1U x 96.021-26

Model 240RBD

Flexible shaft coating

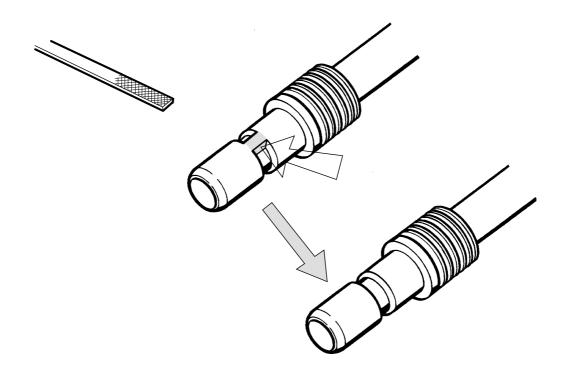
We have decided to remove the rotating stop on the flexible shaft coating to improve manoeuvrability and at the same time increase the service life of the coating. This has been done at the end of the coating located by the throttle. Tilting of the cutting tool has been significantly improved by this measure.

However, you must be attentive to the cabling holding the throttle cable and the short-circuiting cables so that these do not wrap around the flexible coating.

The throttle cable can be stretched and cause unintentional acceleration.

This modification will be introduced into production during week 33; i.e. from serial number 633.

On older machines it's easy to file off the stop in the coating's groove, see fig. below.
